COUNCIL ASSESSMENT REPORT

NORTHERN REGIONAL PLANNING PANEL

PANEL REFERENCE & DA NUMBER	PPSNTH-172 – DA 22/0408
PROPOSAL	Construction of residential flat buildings comprising 79 residential apartments comprising of 3 x 4 storey buildings and 1 x 2 storey building with a common basement
ADDRESS	Lot 46 DP 1264557 – No 6 Grand Parade Casuarina
APPLICANT	Town Planning Alliance (NSW)
OWNER	Azure Project 35 Pty Ltd
DA LODGEMENT DATE	7 July 2022
APPLICATION TYPE	Development Application
REGIONALLY SIGNIFICANT CRITERIA	Clause 2, Schedule 6 of <i>State Environmental Planning Policy (Planning Systems) 2021</i> : Development that has a capital investment value of more than \$30 million.
CIV	\$66,575,000.00 (excluding GST)
CLAUSE 4.6 REQUESTS	N/A
KEY SEPP/LEP	SEPP 65 (ADG) and Tweed LEP 2014
TOTAL & UNIQUE SUBMISSIONS & ISSUES	Seven (7) submissions (objections)
DOCUMENTS SUBMITTED FOR CONSIDERATION	Architectural plans, Statement of Environment Effects, SEPP 65 Report, Landscape Plans, Civil plans and Report, Survey, Waste Management Plan, Traffic Report

SPECIAL INFRASTRUCTURE CONTRIBUTIONS (\$7.24)	Not applicable
RECOMMENDATION	Refusal
DRAFT CONDITIONS TO APPLICANT	N/A
SCHEDULED MEETING DATE

Figure 22: Electrical Infrastructure (Source: Engineering Report)

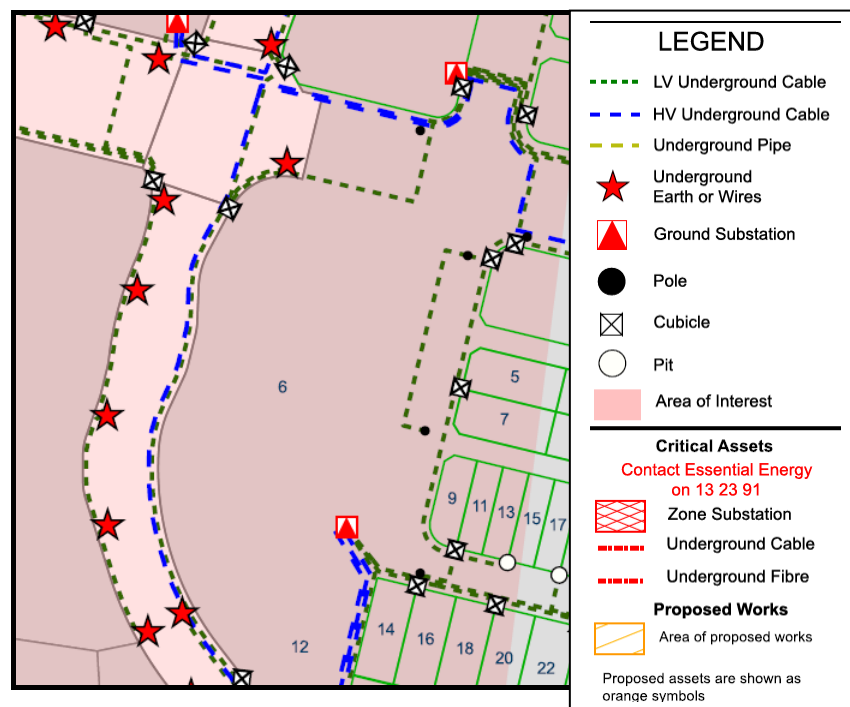
In this case, the site achieves this criteria given there is underground electrical infrastructure located along the northern, southern and western frontages of the site and there is a substation and an associated electricity easement on the site benefiting Essential Energy in the southeast corner of the site (**Figure 22**).

Therefore this section requires consideration (Section 2.48(1)(a) and (b)(i) and (ii)). The application also involves the proposed relocation of the existing pad mount substation from its current location adjacent to Habitat Drive to the southern boundary of the site along Casuarina Way within the front landscaped area.

Pursuant to Section 2.48(2), before determining a development application, the consent authority must give written notice to the electricity supply authority for the area in which the development is to be carried out, inviting comments about potential safety risks, and take into consideration any response. Council referred the amended plans to Essential Energy, with safety concerns being raised by Essential given the proximity to their electrical infrastructure. This is considered further in the key issues section of this report.

Figure 37: Proposed Landscaping (Source: Laud ink Dwg DA-L-9001, August 2023)

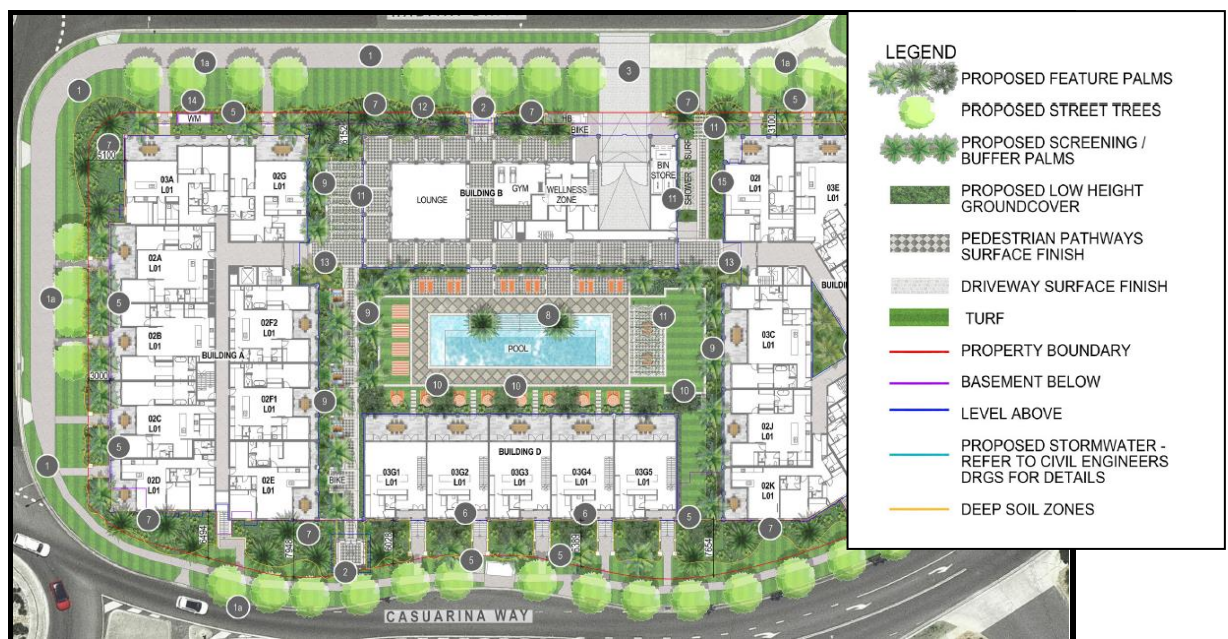
The landscaping for the proposal is largely contained to the communal open space areas and the site frontages adjoining the basement (**Figure 37**). There are a number of concerns with this landscaping as outlined below (in addition to the lack of deep soil areas which is discussed above).

- (a) Street trees - There are existing street trees along all three street frontages, as well as trees along the footpath in the drainage reserve to the south. The proposed landscaping regime heavily relies on this street tree planting outside of the site to provide screening and a landscape setting for the site.

Figure 39: Proposed relocated substation and proximity to proposed building (Source: Level 01 Plan, Conrad Gargett, August 2023)

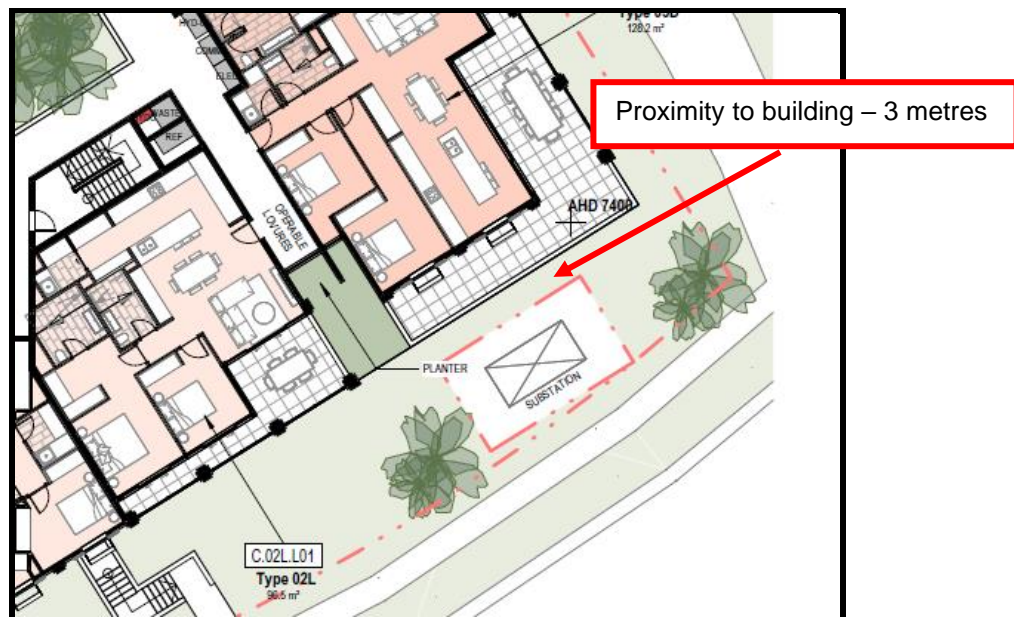
design requirements - 2.14.3 Substations & Switching Stations (Locations). As per AS2067, this type of development requires the substation to be a minimum of 7.5 metres from the nearest building (closest part) unless specific requirements are met e.g. 120/120/120 fire rating, a fire report provided stating why reductions in the distances in AS2067 should be reduced (note Essential Energy must approve the fire report). At present, the proposal does not meet the requirements of AS2067.

The proposal involves a building which is approximately 3 metres from the proposed relocated substation and is therefore unsatisfactory to the electricity supply authority (**Figure 39**). Accordingly, it is considered that the proposal is unsatisfactory having regard to Section 2.48(2)(b) of the Transport & Infrastructure SEPP. It is considered that the proposed proximity to electrical infrastructure for the proposal is unsatisfactory and is not supported. This matter warrants refusal of the application.

Figure 40: Proposed blank elevations - Building B

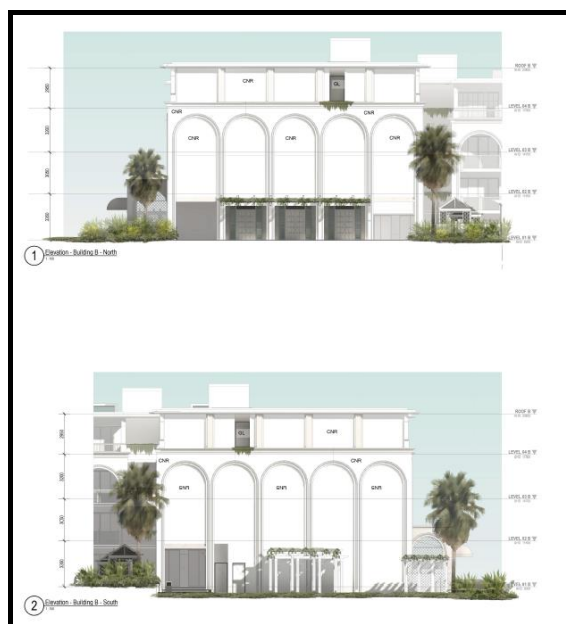
While the proposed buildings generally comply with the building separation requirements, the northern and southern elevations of both Buildings B and D comprise blank elevations as illustrated in **Figures 40** and **41**.

Figure 44: Proposed communal areas (Source: Laud ink, DA-L-9021 Rev 6)

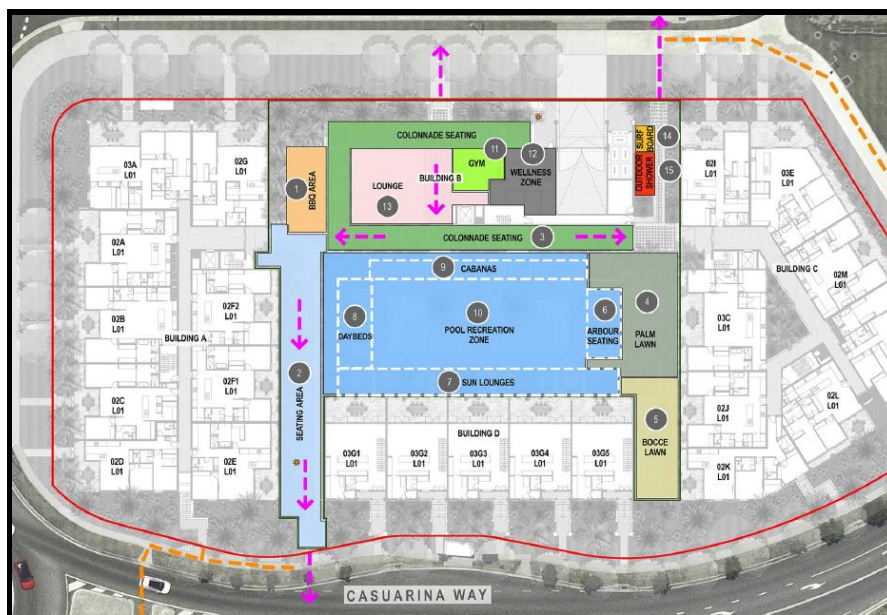
The proposed communal open space ('COS') has been increased and provides a variety of areas for outdoor use by residents. However, this communal open space, being located in the central area of site, adjoins a large number of private open space areas of the proposed apartments. This is contrary to Objective 3F-2 of the ADG in that the communal open space, common areas and access paths are not separated from the private open space and windows to apartments, particularly habitable room windows (**Figure 44**).

It is also contrary to the Design Guidance in Part 4H-1 for acoustic privacy in that noise sources such as active communal open spaces and circulation areas should be located at least 3 metres away from bedrooms. Design Control 2 (site configuration) of Section A1 of the TDCP 2008 also requires that COS is not to be located such that solar access, privacy and outlook to dwellings are reduced. Privacy is reduced by the proposed COS, therefore the proposal does not achieve this design control of the DCP.

Figure 45: Casuarina Way Setback (Source: Conrad Gargett, August 2023)

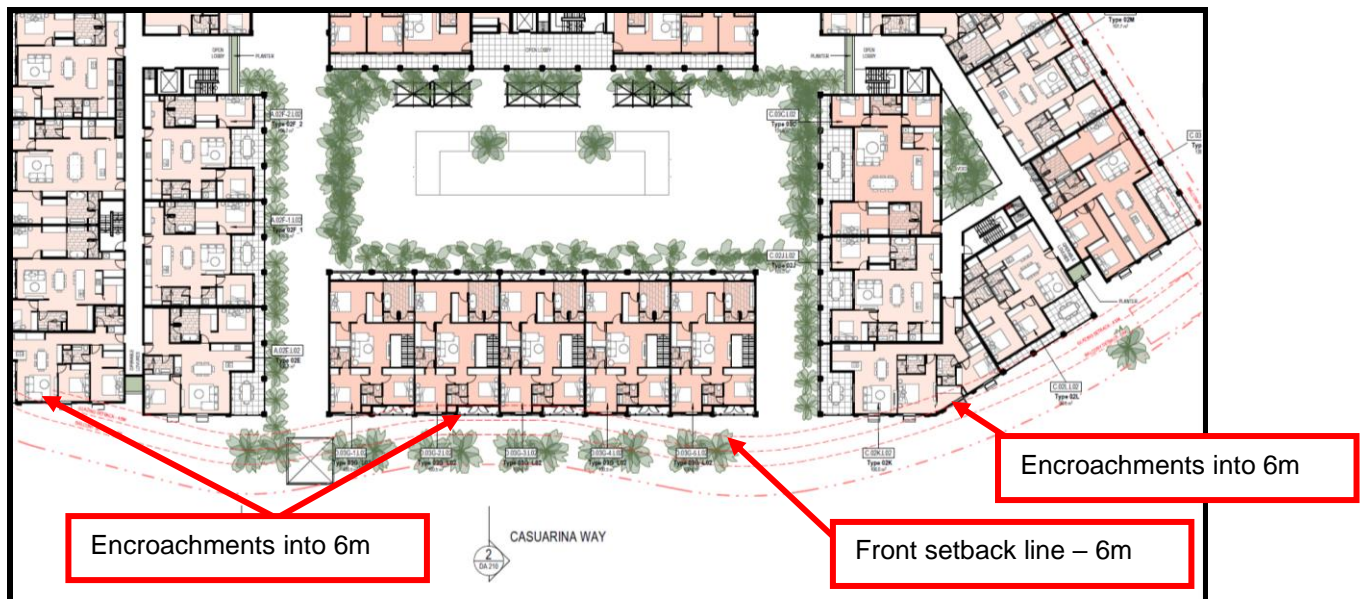
The setback to Casuarina Way is generally 6 metres required by Clause B5.2.2(2)(a), with the following encroachments (**Figure 45**):

- Northwestern corner of Unit type 2D in Building A;
- The front 1 metre including the front balconies of two of the middle apartments in Building D;
- The roofline of Building D overhangs the lower levels increasing the front setback encroachment; and
- South-western corner of Unit type 2K in Building C.

Figure 46: Fencing Plan (Source: *Laud ink, DA-L-9010 Rev 6*)

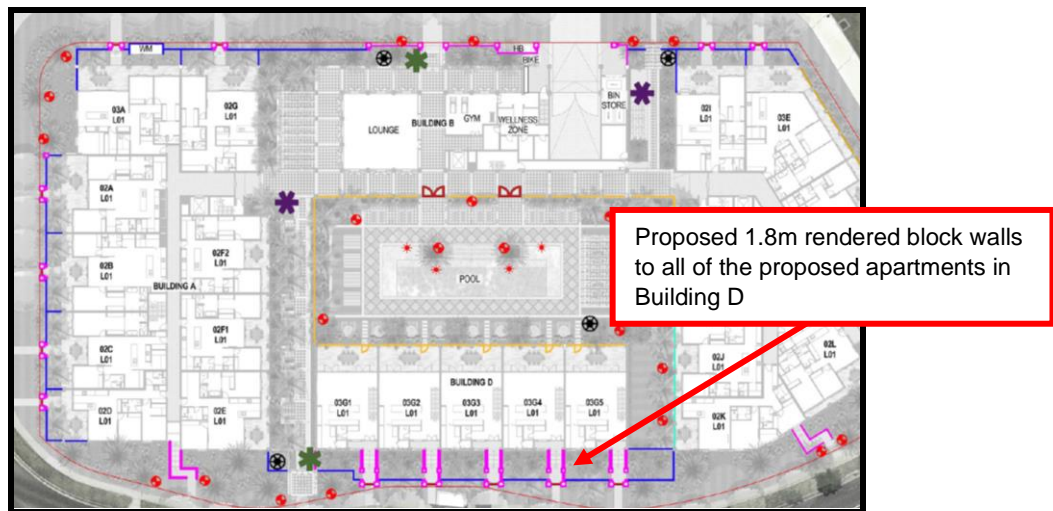
A further concern in relation to the front setback are the proposed 1.8 metre high masonry walls perpendicular to the street boundary adjoining the individual entries to the proposed apartments within Building D (**Figure 46**). These walls are proposed for all of the proposed apartments for Building D along this frontage and are likely to adversely impact on the streetscape and prevent landscaping opportunities for larger trees. The walls, combined with the large hipped roof and raised ground floor level, adversely impacts the streetscape which is unacceptable.

The objective of Part 3G-2 of the ADG in relation to pedestrian access and entries is for access, entries and pathways to be accessible and easy to identify. The design guidance includes that the design of ground floors and underground car parks minimise level changes along pathways and entries and that steps and ramps should be integrated into the overall building and landscape design.

Figure 47: Proposed Building D height above the street (Source: *Conrad Gargett, August 2023*)

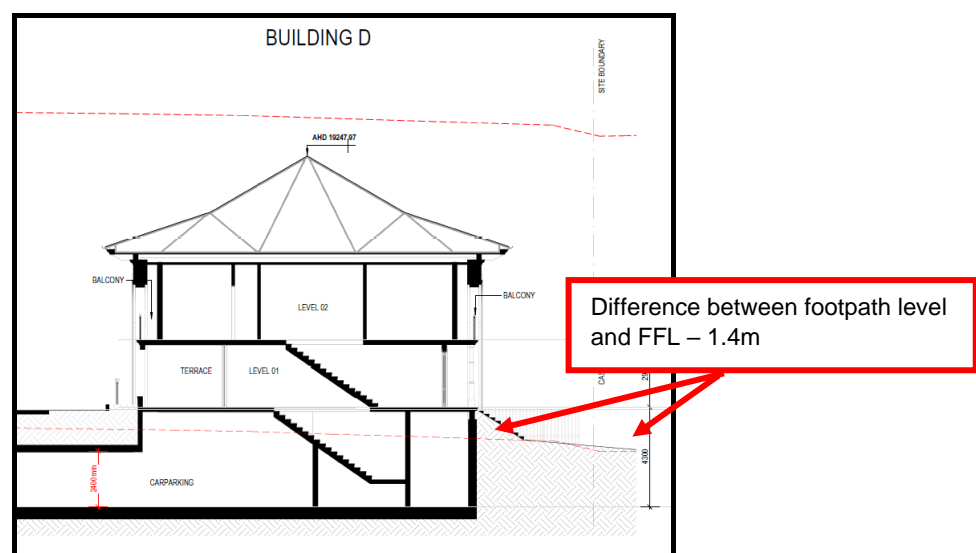
There is a level difference of approximately 1.5 metres between the footpath level at the existing bus stop along Casuarina Way and the ground floor of Building D which results in a large number of stairs and the 1.8 metre high rendered block retaining walls adjoining the stairs (**Figure 47**) perpendicular to the road alignment. This does not provide for steps which are integrated into the building design, with the large walls and stairs reducing the open vistas along the street. The level difference also reduces the adaptability of the proposed apartments in Building D, which require stairs to access from the street as well as from the basement garage which also includes the laundry. There are also stairs to the first floor. The proposed walls and stairs as well as the height of Building D above the street level is unsatisfactory.

It is considered that the streetscape and front setback of components of Building D are unsatisfactory and are not supported. This matter warrants refusal of the application.
